## Further Questions Response Document

**Site name:** Hemerdon Mine Mineral Processing Facility  
**Site address:** Hemerdon Mine, Plympton, Devon PL7 5BS  
**Operator name:** Drakelands Restoration Limited  
**Application reference:** EPR/AP3203ML/A001

Document Ref: SPC0124/Sch 5 Further Questions/TWL November 2023

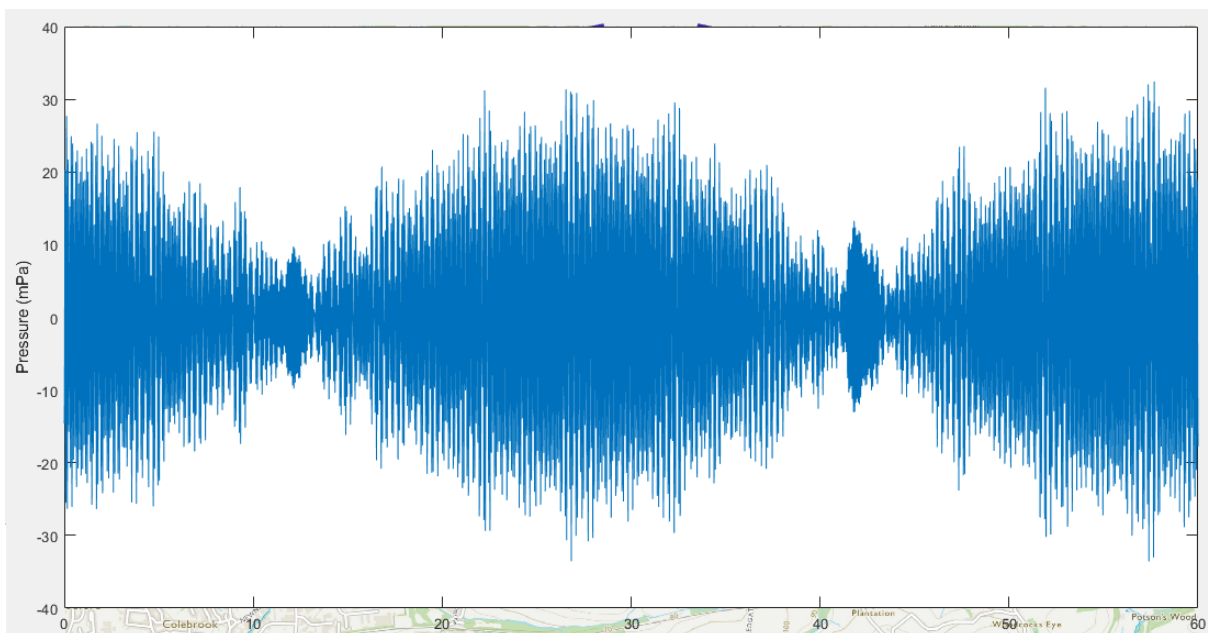
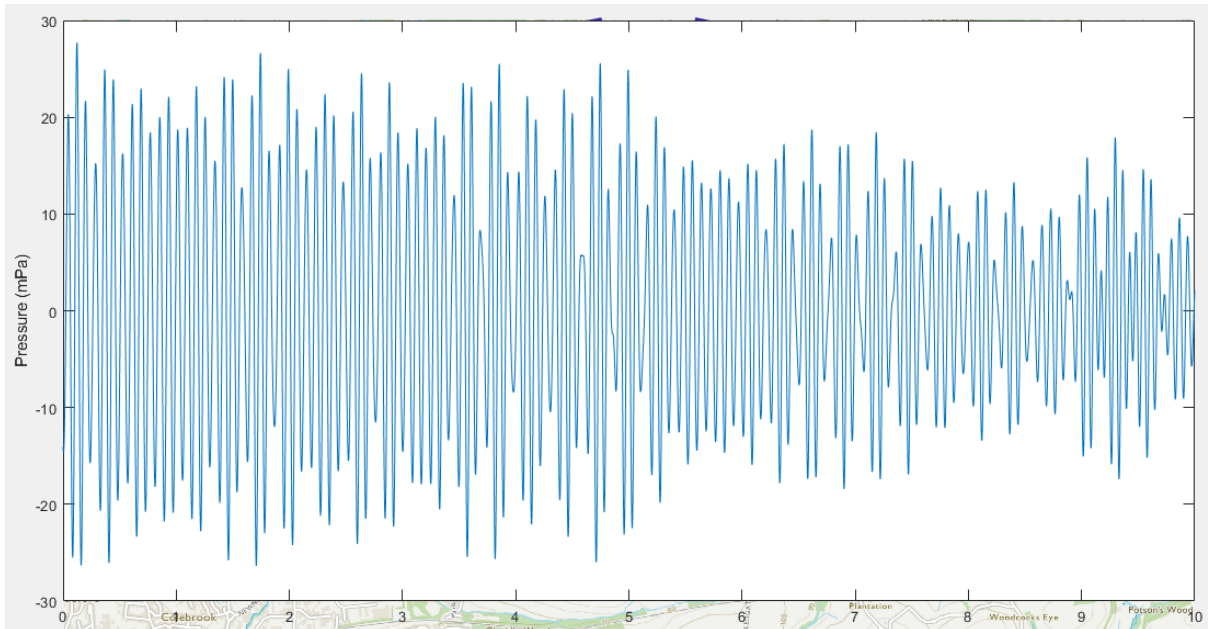
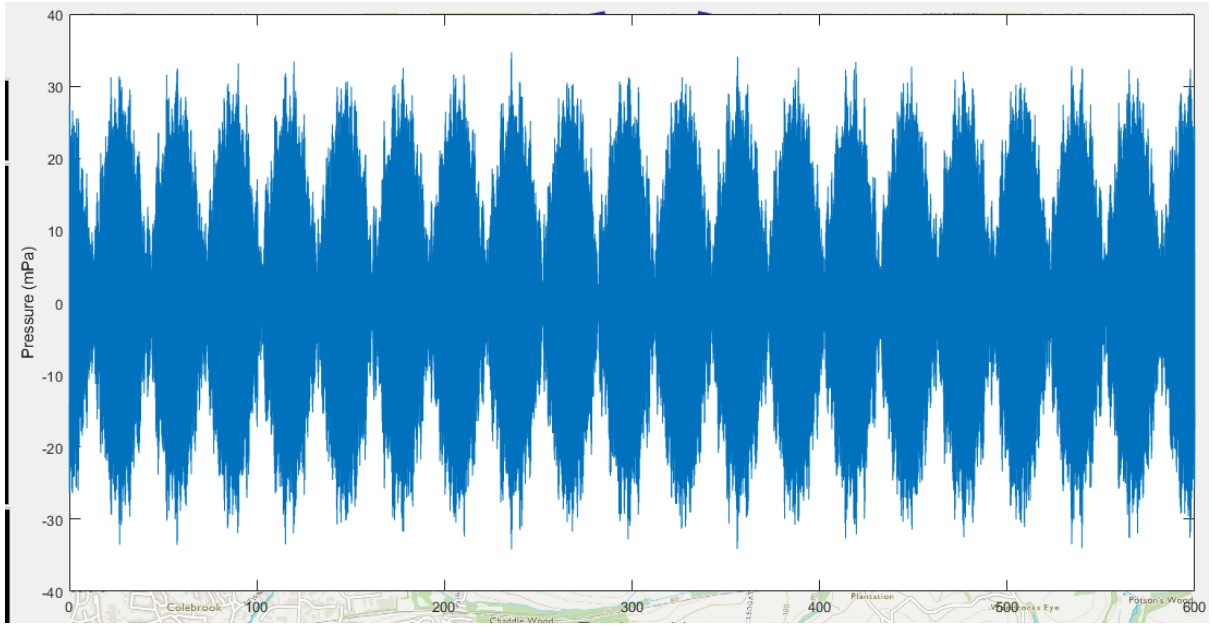
**Provide representative time series plots of predicted sound level at selected receptors with closest proximity to the proposed Mineral Processing Facility, to illustrate likely effects of beating, including repeat period, and the range of sound levels including the highest sound levels which are predicted to occur at those locations. Confirm the time periods represented in the plots.**

*We are aware the predictive model has sufficient functionality to provide time series sound level plots; one was included at Figure 7-1 in the ‘Noise Impact Assessment document V3 dated August 2023’ although the time period was not confirmed. Figure 7-1 was illustrative of the wide variation in sound levels predicted to arise over time at a receptor location from operation of multiple screens, and also the highest periodic sound levels predicted to occur at a receptor location, and how this may be different to a time average level. We consider the closest receptor locations including Portworthy Farm, Birchland Farm, Birchland Road, Galva House, Mumford Cottage, should be included as a minimum.*

Plots are provided in Appendix A- Far field Waveforms. All levels quoted are for a calculation interval of 60 seconds.

In order to demonstrate the effect of varying calculation intervals, below are calculations for Birchland Farm carried out for 10 seconds, 60 seconds and 600 seconds.

For a 10 second period, the SPL was 55.2 dBZ and for 60 and 600 seconds, the value was 55.5 dBZ.

The peak pressure was 35 mPa. If this had come from a sustained single frequency waveform, the rms level would have been 24.7 mPa which equates to 61.9 dBZ.

By comparison, the calculation from the Wolf screens, taking the peak pressure of 347 mPa and assuming a sustained single frequency gives 81.8 dBZ which demonstrates an order of magnitude improvement over the previous operator.
